| SB Number: | SB PF-005 | Creation Date: 16/08/2004 |
| Subject: | Firmware upgrade (usage of PF-410 on KM-1650 / 2050 / 2550) | |
| Model: | PF-410 | |

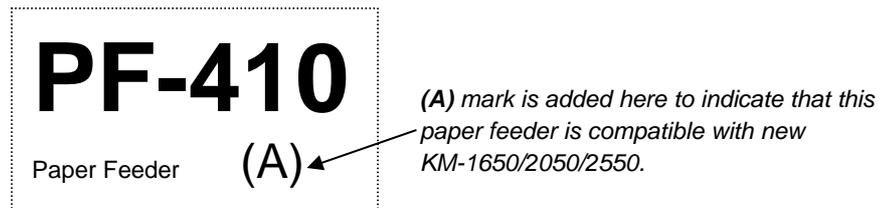
Please be informed that the firmware of the PF-410 has been upgraded to achieve compatibility on the **KM-1650 / 2050 / 2550**.

Version 0011 → 0013

As for the PF-410 that include firmware level 0013 or later, an (A) mark has been added under the product name on the outer carton.

PF-410(A) = **NEW TYPE** / Compatible with KM-1620 / 2020 AND KM-1650 / 2050 / 2550.
PF-410 = **OLD TYPE** / Only compatible with KM-1620 / 2020.

It is not possible to rewrite the firmware of the PF-410 in the field as it is a masked CPU. Main PCB Ass'y will need to be replaced. Therefore please check carefully and use the proper combination at all times: PF-410(A) with KM-1650 / 2050 / 2550!
